To: People In Need of Environmental Safety

From: Mark Hutson, PG 
Indiana LPG, License # 794, Expires 30-Apr-07
Charles H. Norris 
Indiana LPG, License # 2100, Expires 31-Oct-08

Date: March 30, 2007

Subject: Comments on Pines Area of Investigation Planning Documents

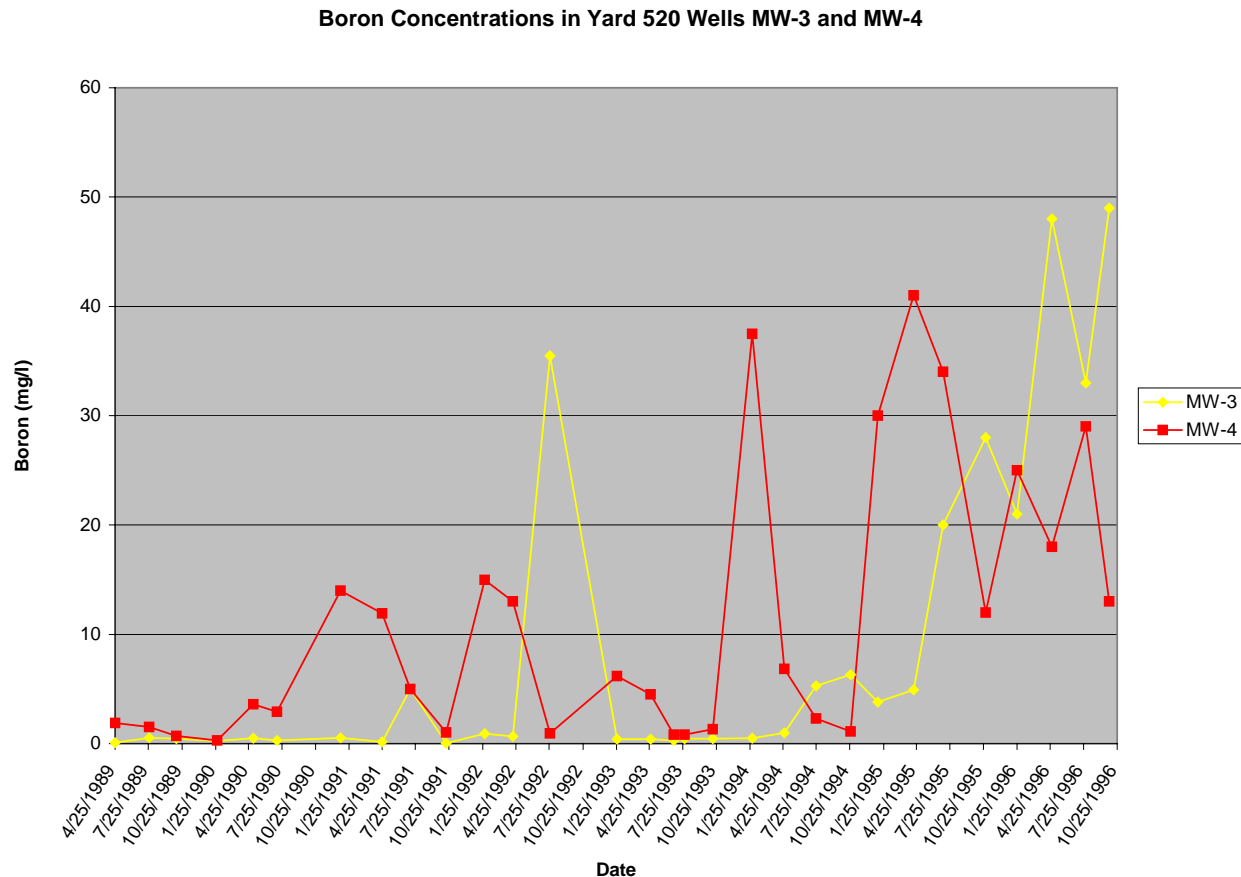
The historical boron analyses around Yard 520 provide an example. GHI obtained historical data from the south unit of Yard 520 monitoring program (See bibliography in SMS Appendix A) and prepared a plot of boron concentrations from Yard 520 monitoring wells MW-3 and MW-4 over the period from 1989 to 1997 (see figure below). These data represent the early monitoring between the south unit of Yard 520 and the then recently-relocated Brown Ditch. The early data on this graph are baseline for these well locations, but do not necessarily represent natural background. This figure shows that boron concentrations in Yard 520 monitoring wells MW-3 and MW-4 were initially relatively low, with MW-3 typically below 0.9 mg/L. By the mid-1990s concentrations of boron for each well had increased by an order of magnitude and more.

These wells were located, constructed and sampled to monitor for downgradient impacts from the south unit of Yard 520, and were accepted by the agency for that purpose. There is no ambiguity or uncertainty. The south unit of Yard 520 is already shown to be a source of boron contamination to the local groundwater. Other monitoring wells similarly demonstrate that the north unit of Yard 520 is a
